Delegated Report		oort	Analysis sheet		Expiry Date:	14/02/2022			
		1	N/A		Consultation Expiry Date:	12/03/2022			
Officer				Application N	umber(s)				
Obote Hope				2021/6205/P					
Application Address				Drawing Numbers					
32 Hartland Ro				J					
London									
NW1 8DD				See draft decis	sion				
PO 3/4	Area Tear	n Signature	C&UD	Authorised Of	fficer Signature				
		<u>_</u>			<u>_</u>				
Duran a sal(a)									
Proposal(s)									
Erection of a single storey rear ground floor extension with green roof; enlargement of first floor rear									
window and installation of access hatch for the use of the flat roof as a terrace.									
Recommenda	ition(s):	s): Refused planning permission							
Application T	Application Type: Householder Application

- **1.0** Planning permission is sought for the erection of single storey rear extension, replacement of the existing rear window at first floor level with an enlarged one window and the main roof of the dwelling would be used as a terrace following the installation of a replacement access hatch.
- 1.1 The existing single storey rear extension would be demolished and be replaced by a single storey rear extension on the footprint

Image 1. Showing the existing and proposed garden plan.

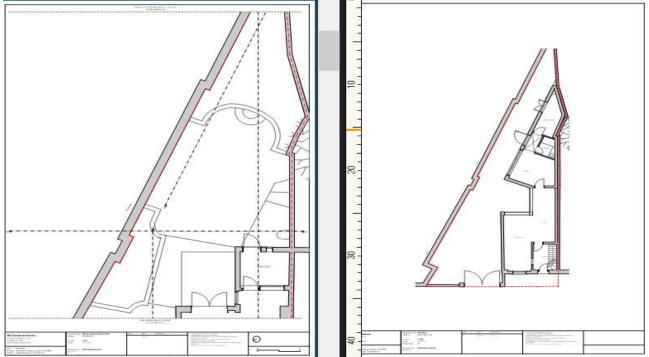
- 4.5 CPG Home Improvements states in relation to rear extension that they should retain the open character of existing natural landscaping and garden amenity. The garden area of the application site is greatly reduced by the Network Rail access requirements on the site. The proposed extension would cover all the remaining garden area after the access requirements have been included, which would be to the detriment of the occupiers. Whilst the structure would have a green roof, this would only accommodate a limited level of planting, lower than that of what a garden space could provide. Given the extension's height and large expansion, it would be an inappropriate addition that would result in loss of substantial amount of garden space which fails to preserve or enhance the open character of the area.

Image 2. Showing in blue the area reserved for Network Rail.

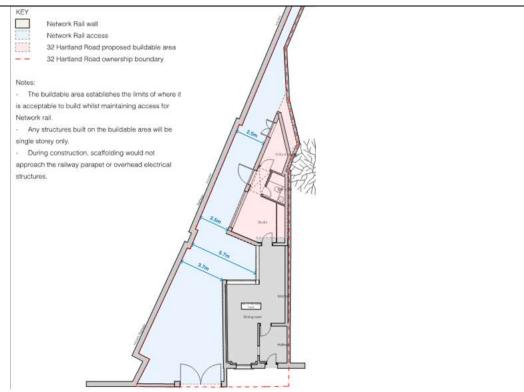
1.2 To north-east the site is bordered by the Overground rail line. The agent confirmed that Network Rail were contacted regarding the easement and access requirements for the railway viaduct, and the extension would not impact on this. The brick viaduct is over 10m above external ground floor FFL and an overhead electricity stanchion is supported along the viaduct wall within the garden. The arches are inaccessible from 32 Hartland Road and have been bricked up. The railway viaduct is owned by Network Rail requires a 2.5m access zone along the full length of the garden adjacent to it, and the large courtyard opposite the electricity stanchion as shown in blue in image 2, below.
